File Number	PLPR-2409-0002	Contact	Chris Lee, clee@duluthmn.gov	
Type	MU-C Plan Review	Planning Commission Date	October 8, 2024	
Deadline for Action	Application Date	September 4, 2024	60 Days	November 3, 2024
	Date Extension Letter Mailed	September 14, 2024	120 Days	January 2, 2024
Location of Subject	4250 Haines Rd			
Applicant	Arola Architecture Studio, LLC	Contact	Ryan Arola	
Agent	F.I. Salter	Contact	Sandy Hoff	
Legal Description	PIN: 010-2710-04490			
Site Visit Date	September 21, 2024	Sign Notice Date	September 24, 2024	
Neighbor Letter Date	September 20, 2024	Number of Letters Sent	12

Proposal: Applicant is proposing the development of a new tunnel car wash.

PLPR-2409-0002
 MU-C Planning Review
 4250 Haines Road

Sheet Title
PRELIMINARY LAYOUT

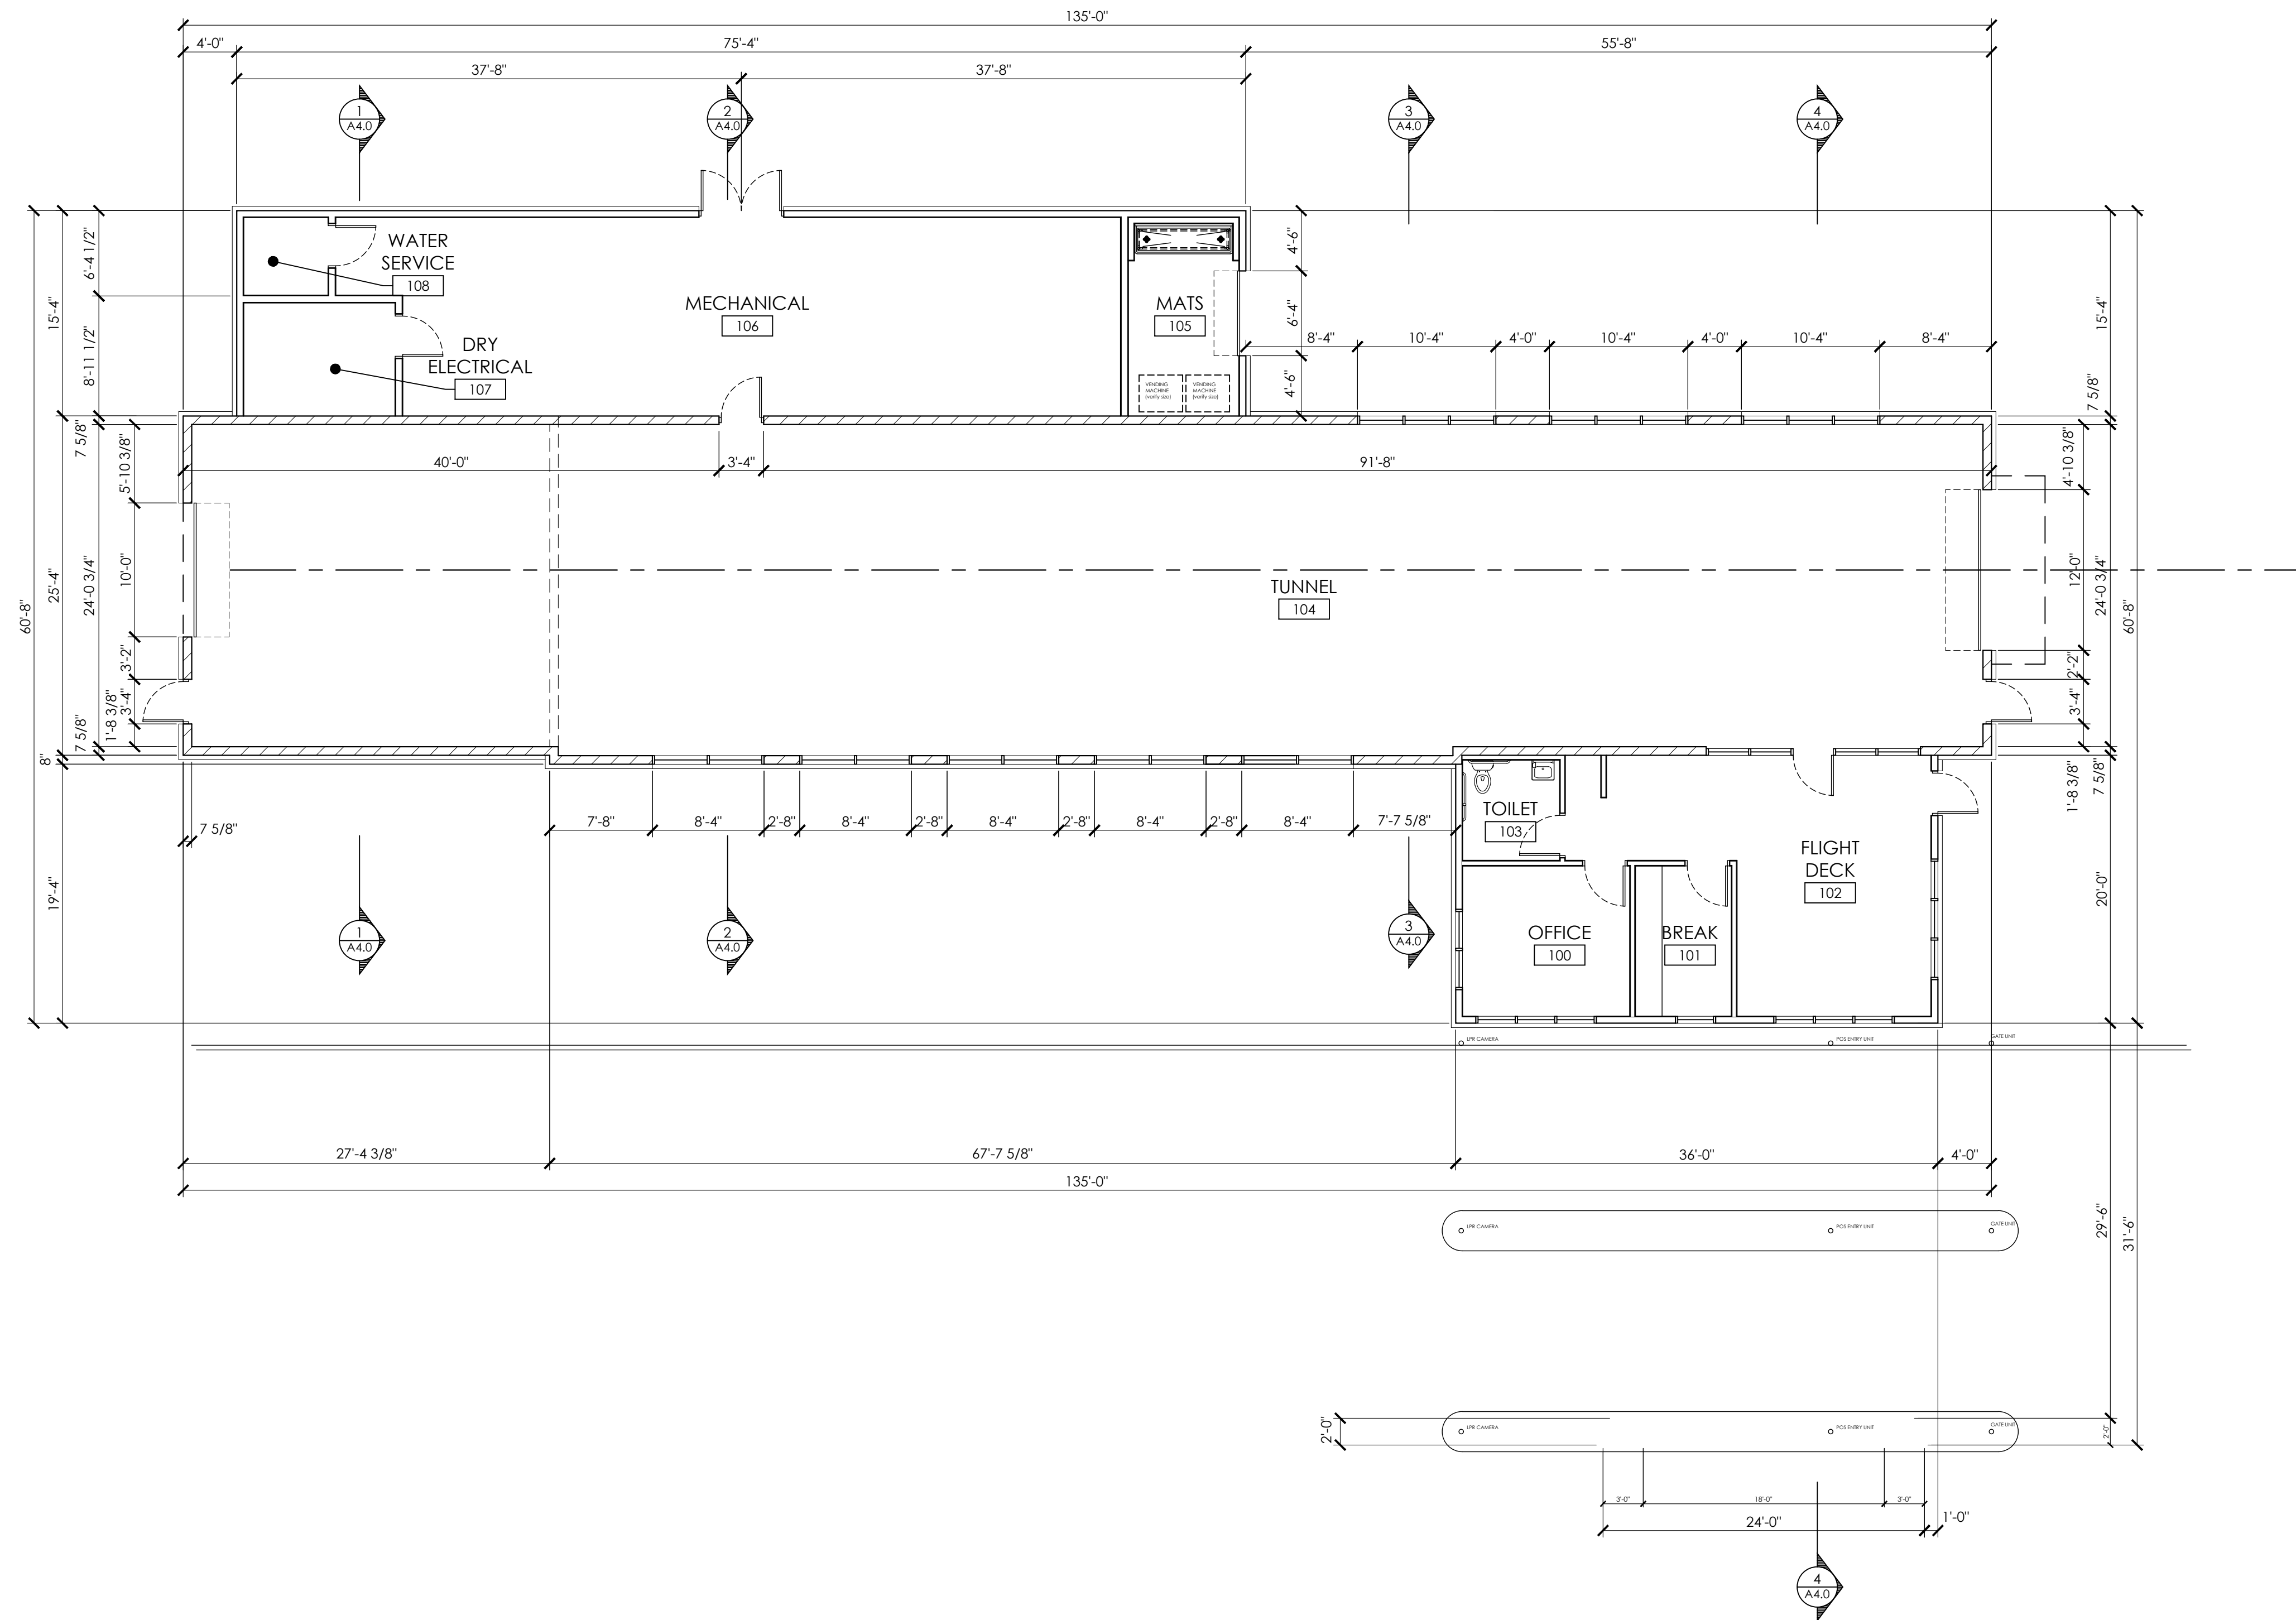
- 2) UDC 50-24 Sec. (Parking and loading). This use does not have a maximum parking limit, but the applicant is proposing 4 parking stalls for customers and employees not using the washing or vacuuming facilities. As proposed, the facility will have space to allow stacking for 15 cars to prevent vehicles from backing up onto Haines Road.

- 4) UDC Sec. 50-26 (Screening, Walls and Fences). The trash enclosures are proposed near the north property line. A dense urban screen is required as a use specific standard for car washes in the MU-C district. The applicant will need to submit plans showing that screening is installed on the north property line prior to receiving the building permit.

- 1) Applicant shall submit a landscaping plan that fully conforms with the requirements of the UDC and this landscaping plan will be approved by the Land Use Supervisor prior to receiving a building permit;

- 2) Applicant shall submit a lighting plan with photometric plan and drawings for fixtures that fully conform to the requirements of the UDC, and this lighting plan shall be approved prior to receiving a building permit;

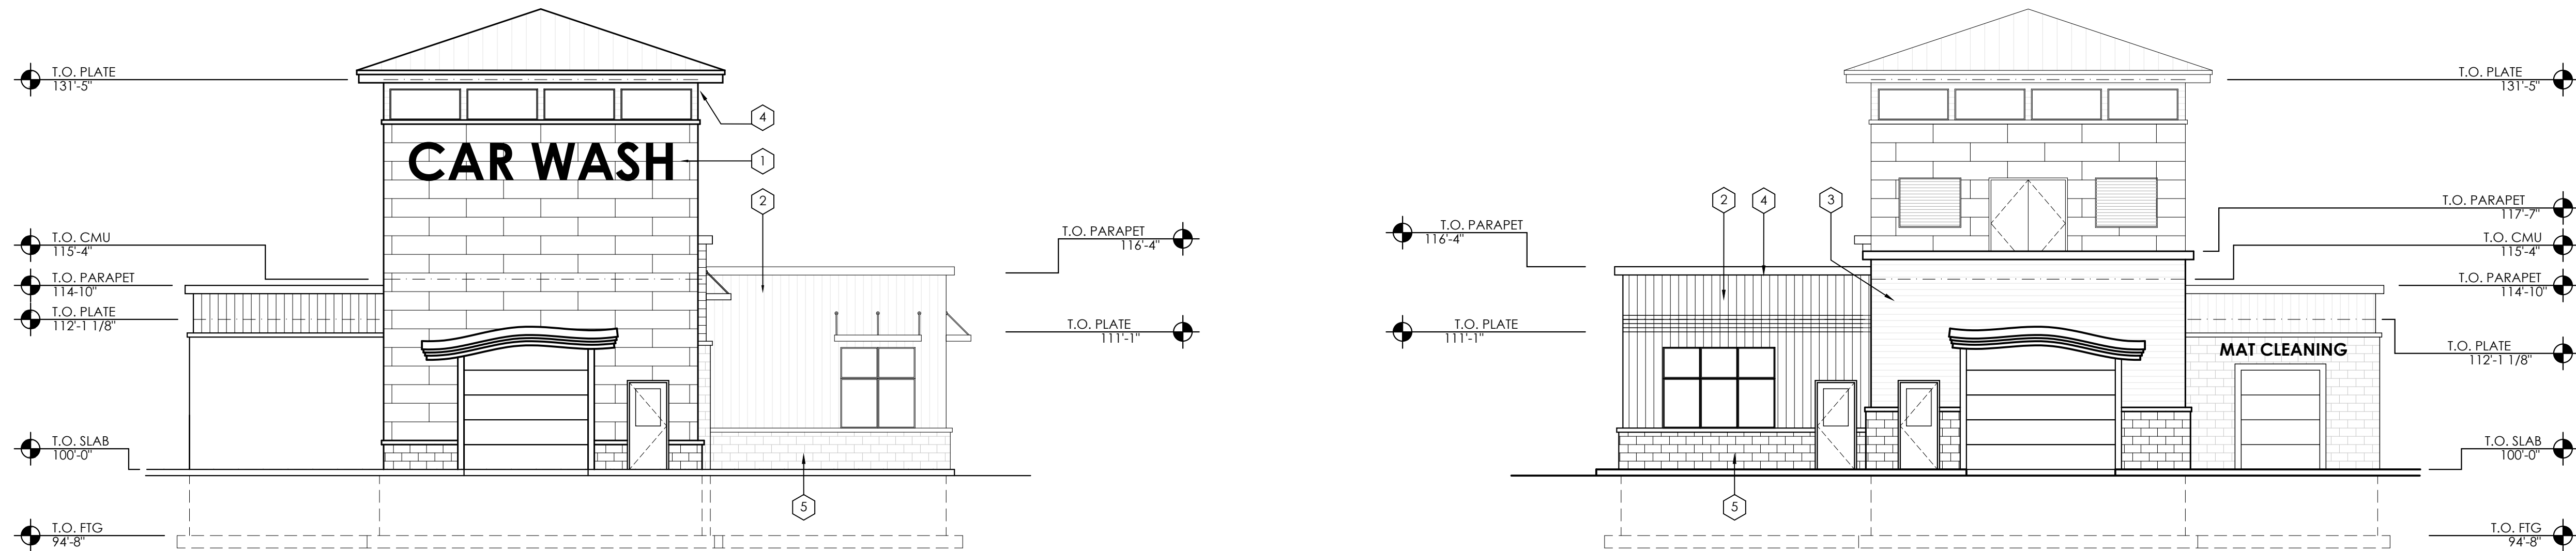
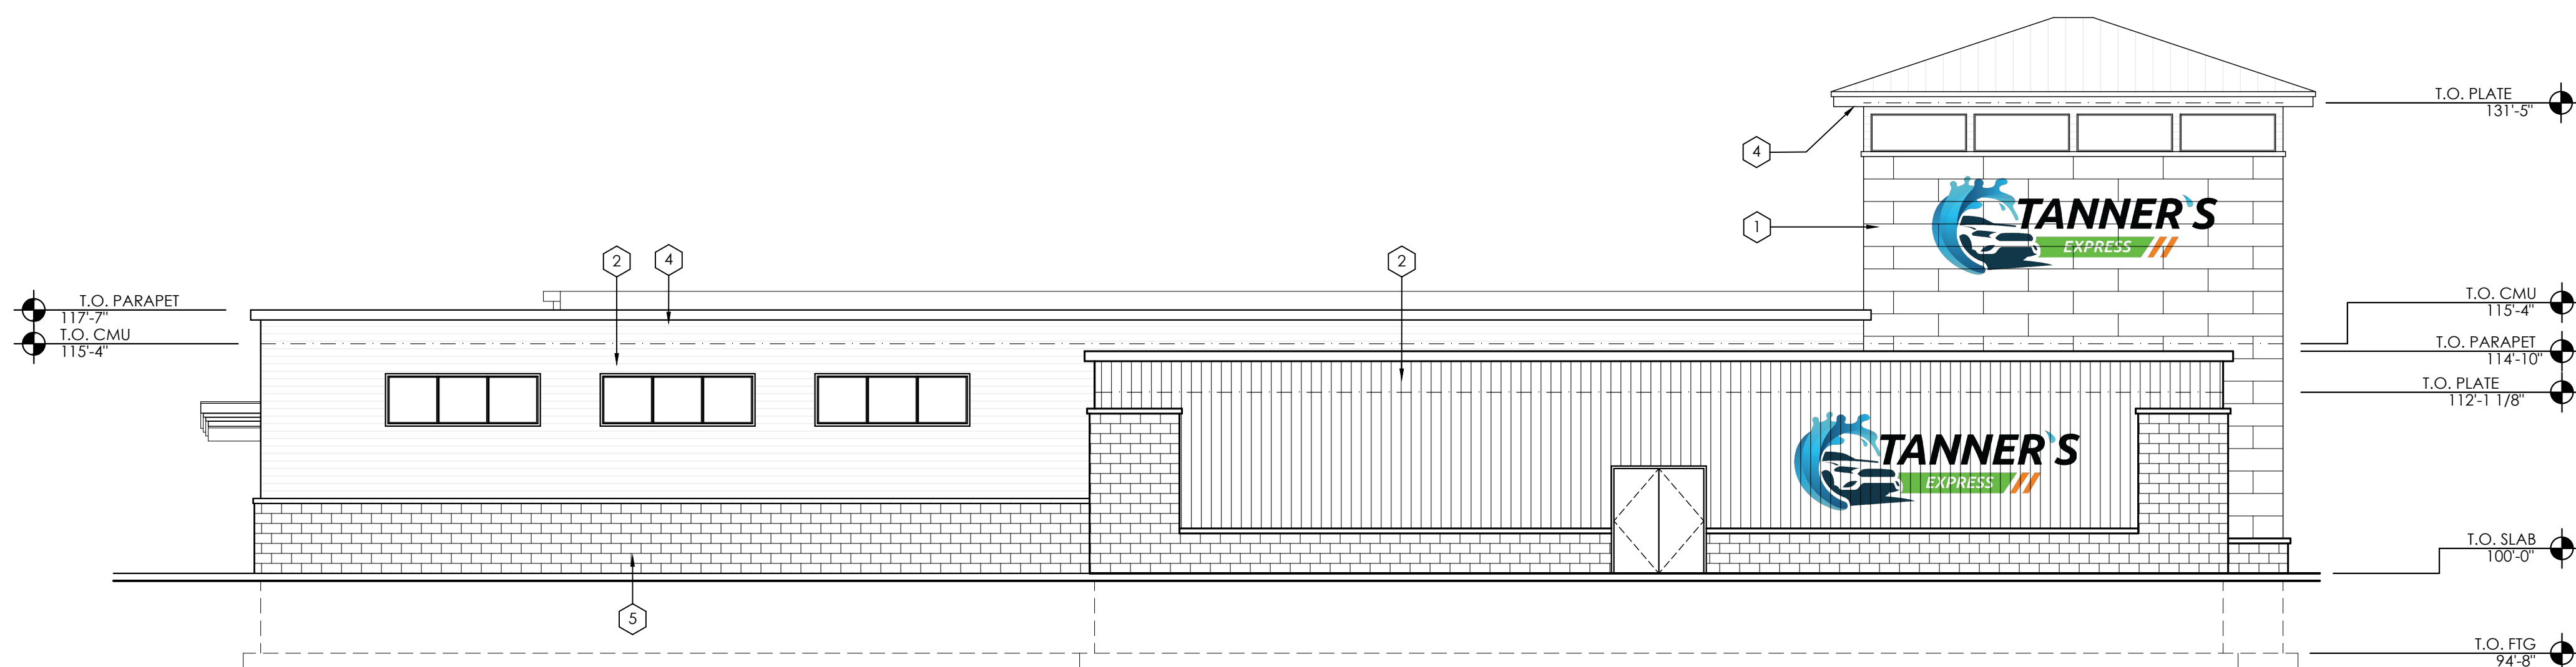
- 6) UDC Sec. 50-30 (Design Standards). The proposed structure meets these requirements for wall articulations, vertical articulations, and transparency.
